Addendum #1

RFP R40797

Boston Daniels Park-Playground Equipment & Surfacing

Re | Playground RFP Questions from Bidders

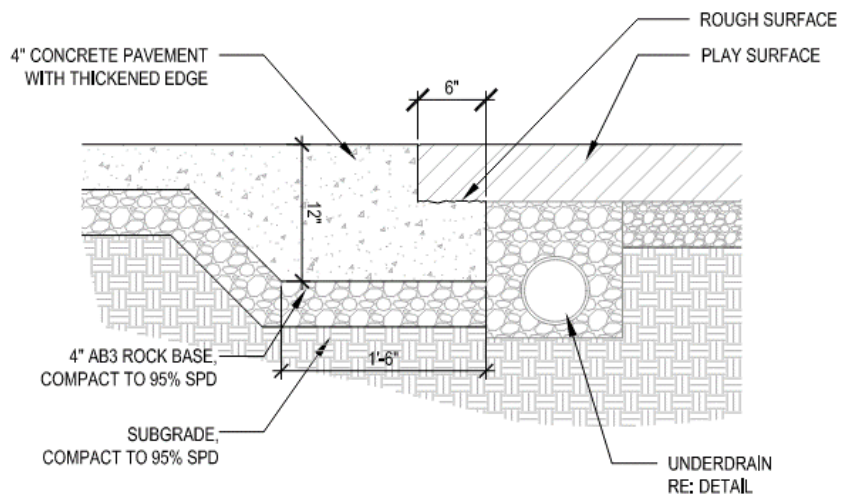
- a. **Answer:** Yes, artificial turf is an acceptable alternative to poured-in-place surfacing.
4. **Question:** Is the site plan set in stone, or can we reduce it a bit to also help save on surfacing cost?

- a. **Answer:** The playground footprint provided is pretty much set in stone. However, should this be more room than what the budget allows for your proposed design(s), we may be able to either shrink the footprint, convert

portions to natural grass, plant beds, or create additional seating areas. Please show the edge extent of proposed surfacing if smaller than the footprint provided.

NOTE:
 THIS DETAIL SHALL BE USED AT ALL
 LOCATIONS WHERE THE SIDEWALK
 ABUTS PLAY SURFACING

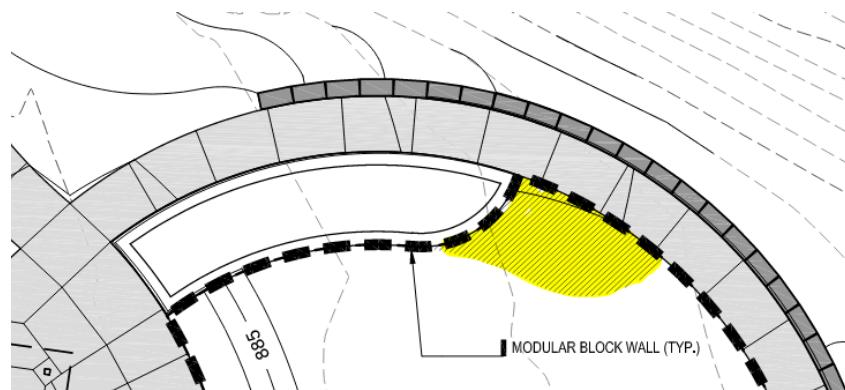
8. **Question:** Does the city plan to curb or wrap the pour in place?
 - a. **Answer:** A 12" depth thickened concrete edge along the sidewalk will be provided by the General Contractor. See image below.

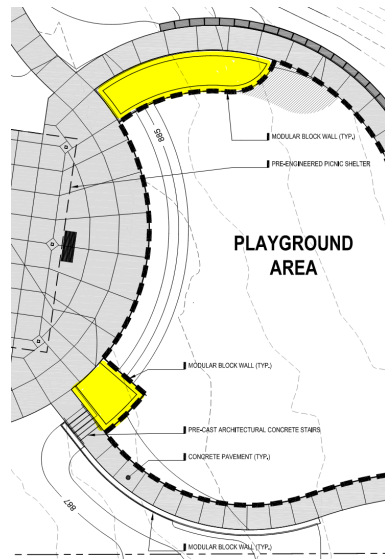
- a. **Answer:** Yes, installation of your proposed surfacing material is to be included in the budget.
13. **Question:** What does the cross hatch towards the north end of the playground indicate?

- a. **Answer:** This cross hatch indicates an area where there may be some slope, or grade transition, from the sidewalk into the playground area.
14. **Question:** Would Wyandotte County prefer to have a swing included in the design or is the county interested in a diversity of play features without preference for a swing?
 - a. **Answer:** Wyandotte County is interested in a diversity of play features. We recognize that the safety zone for swings takes up a large amount of real estate which may limit both the quantity and diversity of other play equipment. If there is an opportunity to provide swings they will be welcomed, but swings are not a must have.
